**APPENDIX H**

**CITY OF LOS ANGELES**  
INTER-DEPARTMENTAL CORRESPONDENCE

5001 W. Wilshire Bl  
DOT Case No. CEN21-50601

Subject: **TRANSPORTATION ASSESSMENT FOR THE PROPOSED MIXED-USE PROJECT LOCATED AT 5001 WEST WILSHIRE BOULEVARD**

FIGURE  
1A

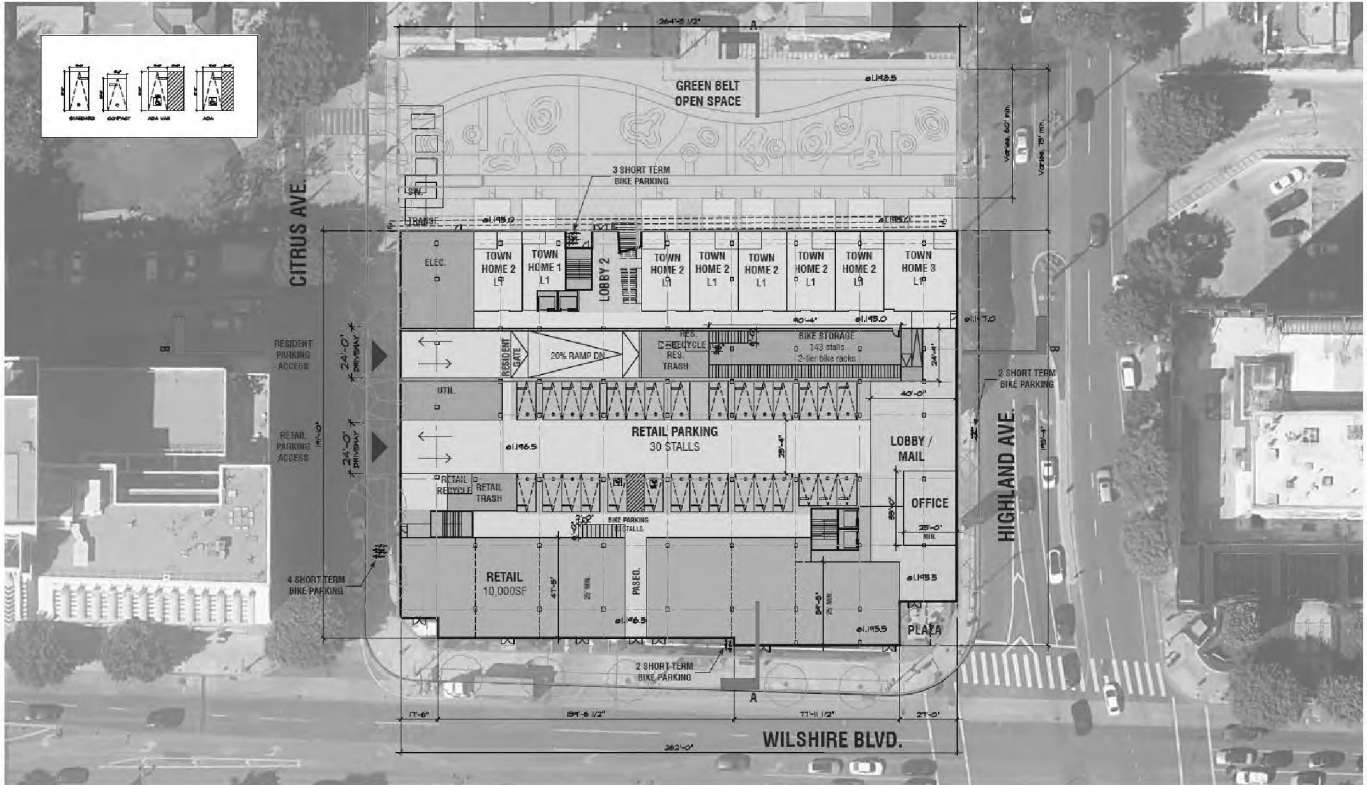
The conceptual site plan for the project (see **Attachment A**) is acceptable to LADOT. Review of this study does not constitute approval of the dimensions for any new proposed driveway. Review and approval of the driveway should be coordinated with LADOT's Citywide Planning Coordination Section (201 North Figueroa Street, 5th Floor, Room 550, at 213-482-7024). In order to minimize and prevent last minute building design changes, the applicant should contact LADOT for driveway width and internal circulation requirements prior to the commencement of building or parking layout design. The applicant should check with City Planning regarding the project's driveway placement and design.
